**N4872A-01**

# **S E R V I C E                      N O T E**

## **N4872A 13.5 GB/S GENERATOR MODULE**

**Pro-active –24V fix**

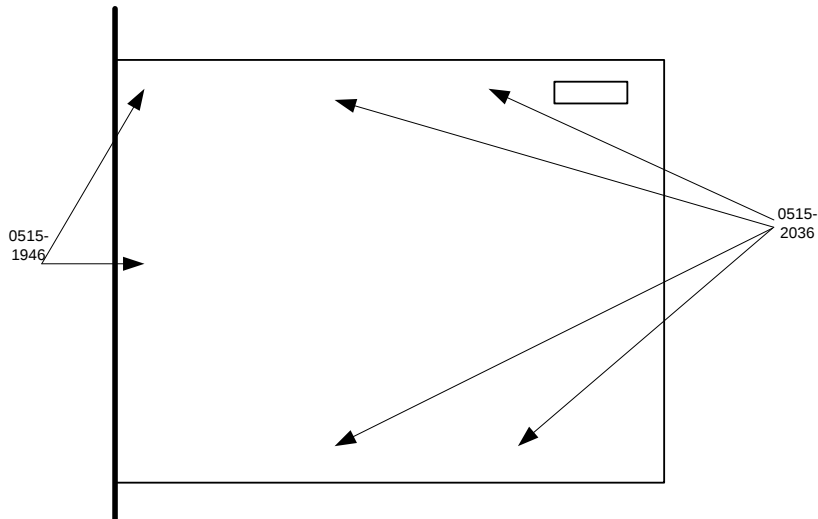
Module draws too much current on -24V in some Mainframes. Resulting from that the -24V fuse blows. The error message “Self-test failed: Voltage of -24V is out of valid range-330” will appear during module self test. If you see this failure, the fix described below is too late. The module needs to be repaired.

Remove six Torx screws and open module.
